SUBDIVISION REPORT - CONCEPT

▶ **FILE #:** 2-SB-24-C

▶ **SUBDIVISION:** MORNING RIDGE

CONCEPT PLAN

C1
 CONCEPT PLAN
 12/20/23

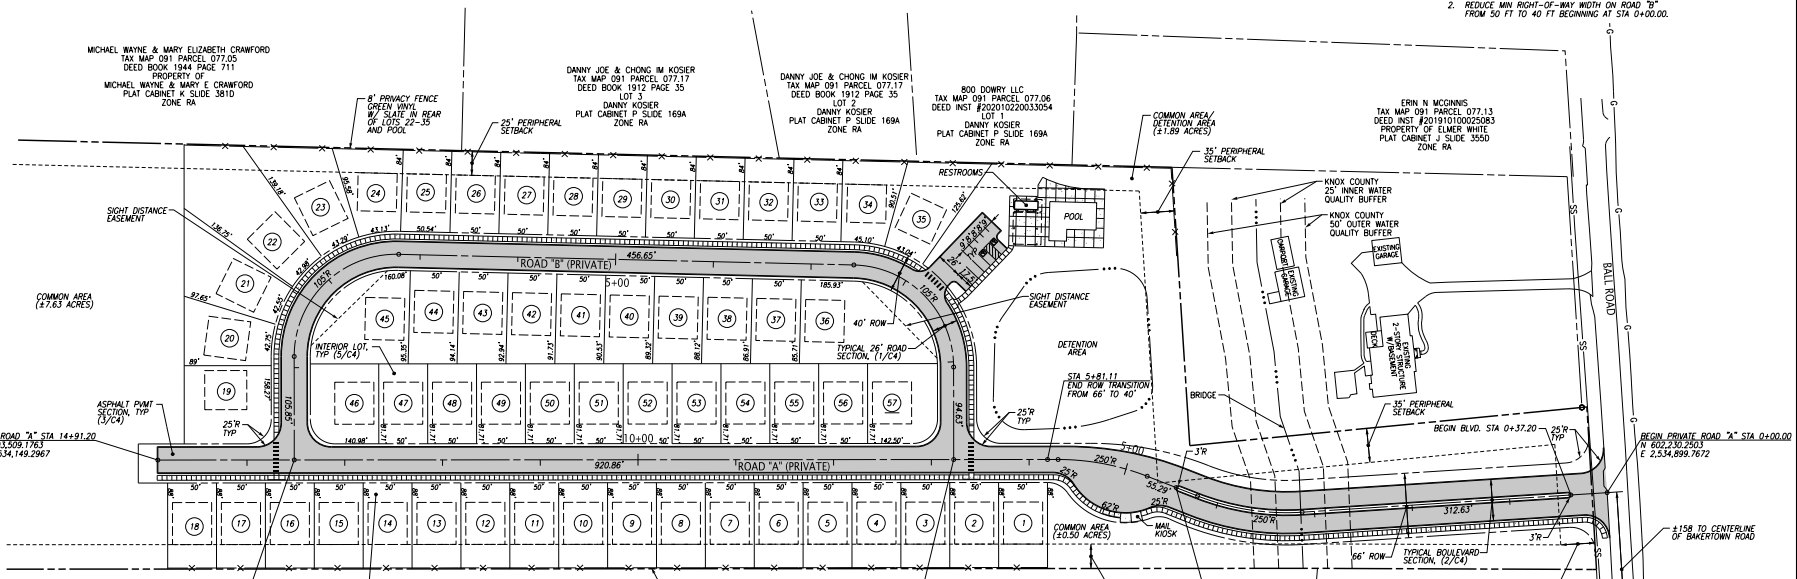
- 1) Reduce the minimum intersection separation between Road "A" and Bakertown Rd from 300 ft to 150 ft.
- 2) Reduction of vertical curve K value from 25 to 15 on Road "A" at VPI STA 0+38.48.
- 3) Reduction of vertical curve K value from 25 to 20 on Road "A" at VPI STA 1+51.40.

- 1) Reduce the minimum horizontal curve radius from 250 ft to 105 ft for Road "B" from STA 0+94.63 to STA 2+56.26.
- 2) Reduce the minimum horizontal curve radius from 250 ft to 105 ft for Road "B" from STA 7+21.91 to STA 8+88.58.

1) Reduce the minimum right-of-way width on Road "A" beginning STA 5+81.11 and Road "B" beginning STA 0+00.00 from 50 ft to 40 ft.

This proposal is for a revised 57-lot residential subdivision on this 19.61-acre property on Ball Rd, a major collector street. The property is zoned PR (Planned Residential) up to 3 du/ac. The proposed density is 2.91 du/ac. A concept and development plan were previously approved for this property in 2022 (3-SD-22-C/3-F-22-UR). Since the number of units and dwelling type will not be changing, only a concept plan is required.

This proposal has removed the dedication of right-of-way on Bakertown Rd, as it is no longer required, and the sidewalk no longer extends along the road frontage of Bakertown Rd. The boulevard entrance has been realigned based on topography constraints and the roundabout and recreation field in the previous approval have been removed. A pool area with parking and restrooms has been added and some lots have been reconfigured to move the detention to one location on the property.

The applicant has requested a boulevard entrance. The use of the designation of 'Boulevard' as a street name is subject to the approval of the Planning Commission (Subdivision Regulations 3.04.K.1). The development has an internal sidewalk system. An 8-ft tall privacy fence will be required along the west and east property boundaries and along the pool area. A peripheral setback reduction from 35 ft to 25 ft was previously approved along the west and east boundaries.

The applicant has 3 variance requests. The variance reductions to the vertical curve K values will allow Knox County to install sidewalks along Ball Rd in the future. The reduction to the minimum intersection separation is necessary because the property is less than 300 ft, the minimum intersection separation distance allowed, from Bakertown Rd. Positioning the road in the proposed location minimizes the impact to the neighboring properties and provides optimal geometry for the road. Planning recommends approval of the requested variances as they meet the criteria in the Subdivision Regulations and are supported by the Knox County Department of Engineering and Public Works.

- Approve the requested variance to reduce the minimum intersection separation between Road "A" and Bakertown Rd from 300' to 150' based on the following evidence of hardship.

Approve the requested variance to reduce the vertical curve K value from 25 to 15 Road "A" at VPI STA 0+38.48 based on the following evidence of hardship.

Approve the requested variance to reduce the vertical curve K value from 25 to 20 Road "A" at VPI STA 1+51.40 based on the following evidence of hardship.

Approve the alternative design standards based on the justifications provided by the applicant and the recommendations of the Knox County Department of Engineering and Public Works.

Approve the concept plan, subject to 8 conditions.

Engineering Comments: Approved based upon justification provided by applicant.

Engineering Comments: Approved based upon justification provided by applicant.

Engineering Comments: Approved based upon justification provided by applicant.

Engineering Comments: Knox County supports the reduction of the ROW on this private road. *Steve Elliott*

Engineering Comments: Knox County supports this request since no unsafe conditions are being created. *Steve Elliott*

Engineering Comments: Knox County supports this request since no unsafe conditions are being created. *Steve Elliott*

C2
 CONCEPT PLAN
 12/20/23

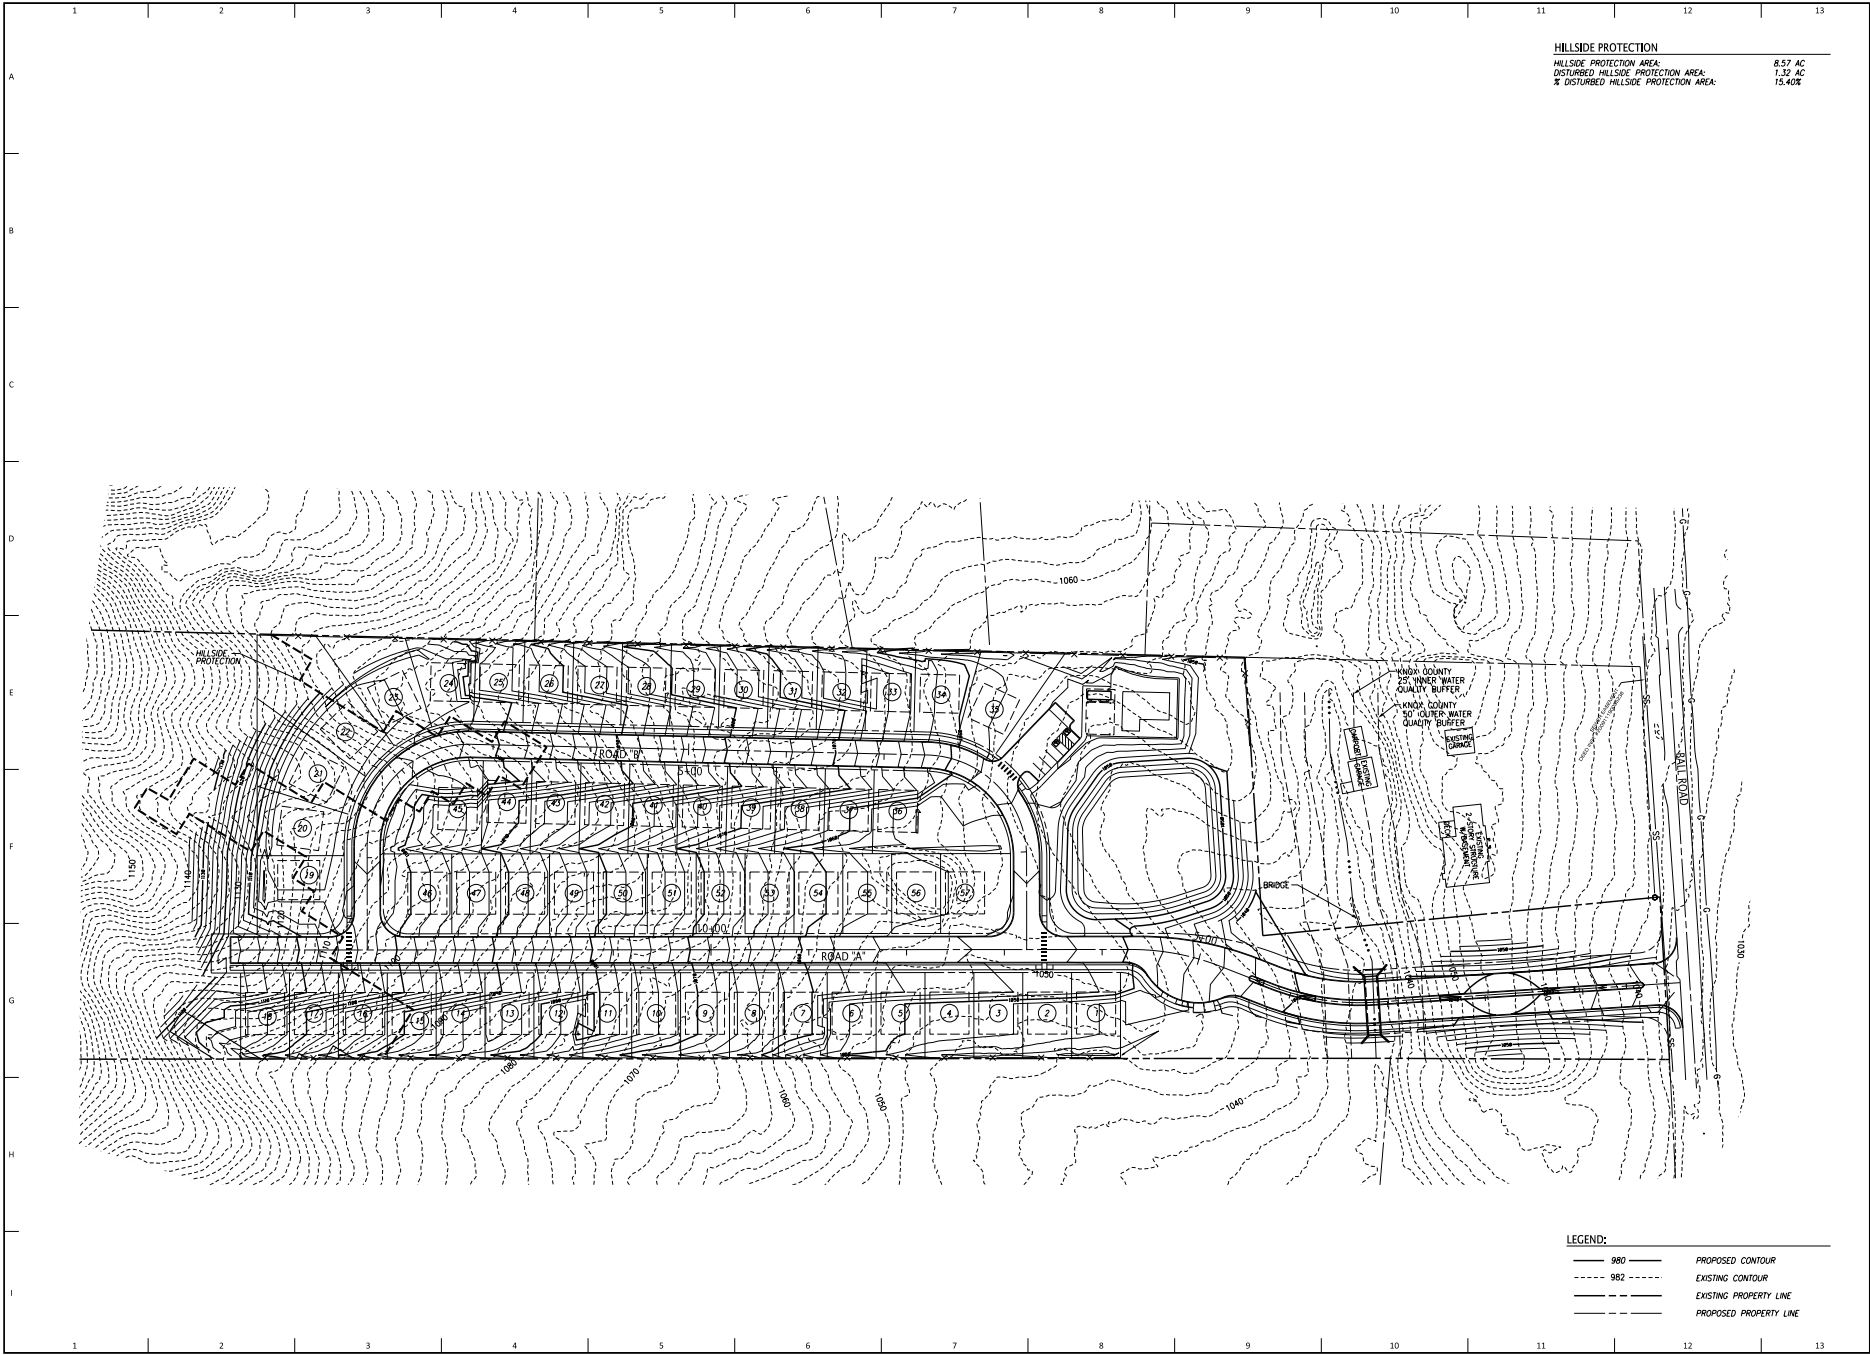
The rear of the property is within the HP (Hillside Protection Overlay) zone. The proposal is for 1.32 acres to be disturbed, which is within the disturbance budget of 2.6 acres. The line of disturbance is also clearly marked on the plan. This is to be verified during the design plan phase and delineated with high-visibility fencing before grading permits are issued for the site.
